Remington Arms Co., Inc.
R&D Technical Center
315 W. Ring Road
Elizabethtown, KY 42701

To: Rich Kosko, The Hanson Group
Subject: Receiver Insert Part Changes (Dwg. E-300327)

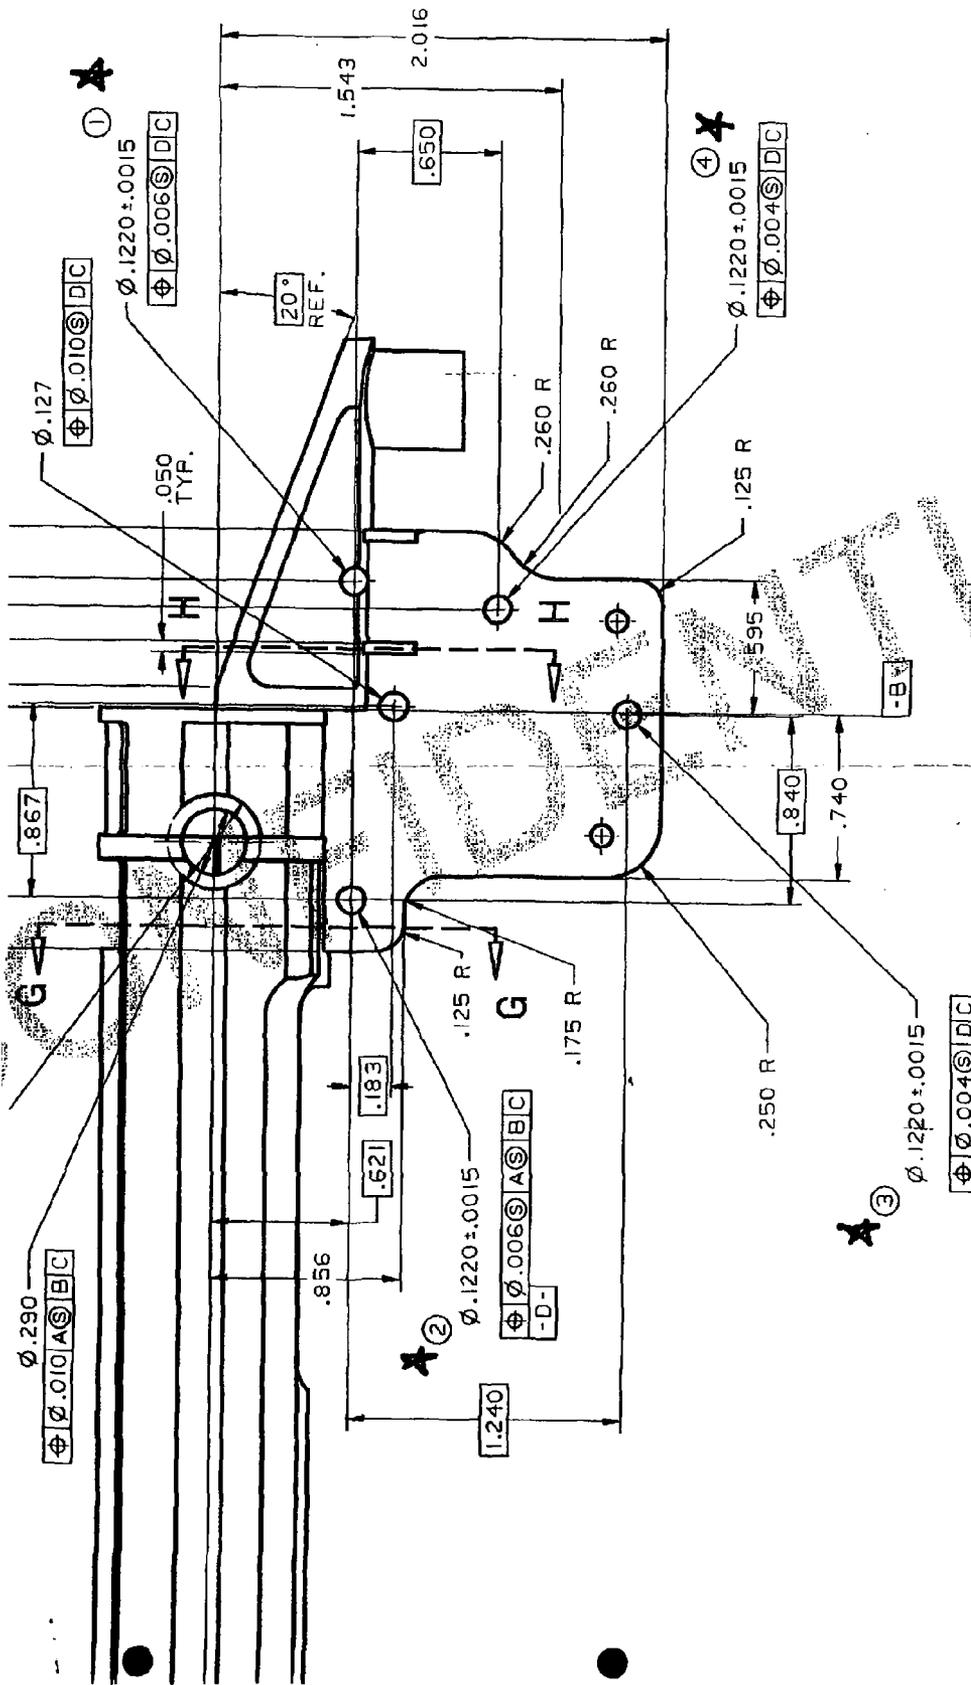
Please find attached a partial section of Drawing 2E-300327, receiver insert. Please note the dimension and tolerance changes for the four holes marked. Based on design requirements, I was able to increase diametral tolerance. To obtain proper fit of the mating cross pin, the diameter of the holes required adjustment. Drawing changes are called out as 1,2,3, and 4 as highlighted. A complete drawing will be mailed today, overnight to your attention. Not shown on the included partial section is design change number 5, which removed a duplicate callout for a .124 diameter hole. Upon receipt of the complete drawing please review, if you have questions please call.
